Comments on the Section 12A Application No. Y/YL-LFS/13

The Conservancy Association OBJECTS to the captioned application.

Figure 1 The proposed rezoning site (marked as red) is within WBA

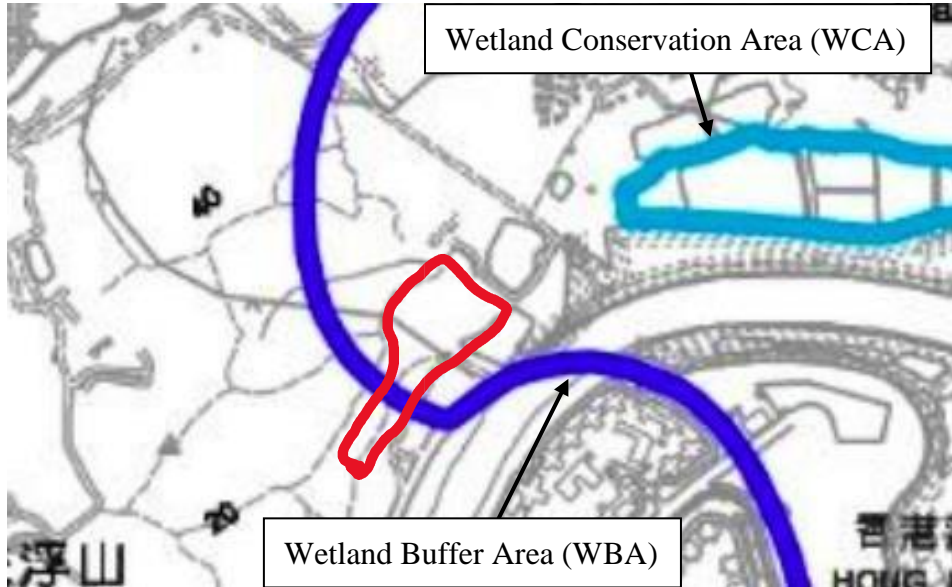
From our observation, a part of the proposed GB site is within WBA (Figure 1). According to Application for Developments within Deep Bay Area under Section 16 of the Town Planning Ordinance (TPB PG-No. 12C), the intention of WBA is “*to protect the ecological integrity of the fish ponds and wetland within the WCA and prevent development that would have a negative off-site disturbance impact on the ecological value of fish ponds*”. Although there are some degraded areas, which may be considered by the board as target areas to allow an appropriate level of residential/recreational development, we found that most of the areas have not been paved yet (Figure 2). The proposed rezoning site still serves the function to “*prevent development that would have a negative off-site disturbance impact on the ecological value of fish ponds*” in WCA.

By introducing a population of 2,352 and 840 flats, such large development scale would potentially induce adverse off-site disturbance impacts on adjacent wetland in WCA, affect ecological function and integrity of Deep Bay wetland ecosystems. We opine that this is definitely not in line with the TPB PG-No. 12C and the planning intention of WBA.
